KIT, SHUT-OFF VALVE WITH PROTECTOR

3108706.023 Kit Includes:

Form No. 3107952.024 7/07

FIG. 1A

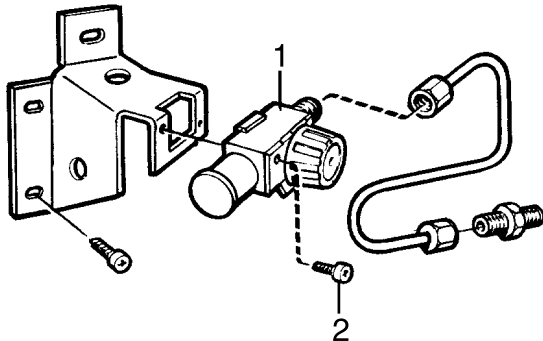
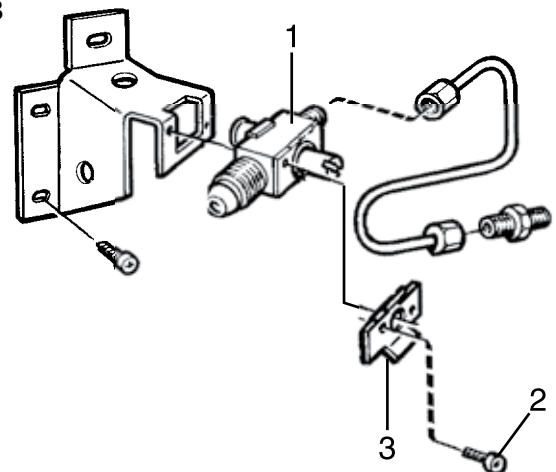
Part number 2007709047 shut-off valve had two different style valves. (See FIG. 1A & 1B)

When replacing the valve with knob (Item 1) as shown in FIG. 1A, a washer protector must be installed for proper valve function. This will prevent the valve shaft from being depressed which could cause the valve to leak.

Remove the two screws (Item 2) that mount the old valve to bracket. (See FIG. 1A) Place the new valve (Item 1) in position with washer protector (Item 3) on front of valve as shown in FIG. 1B. Mount new valve and protector with the two screws removed from old valve.
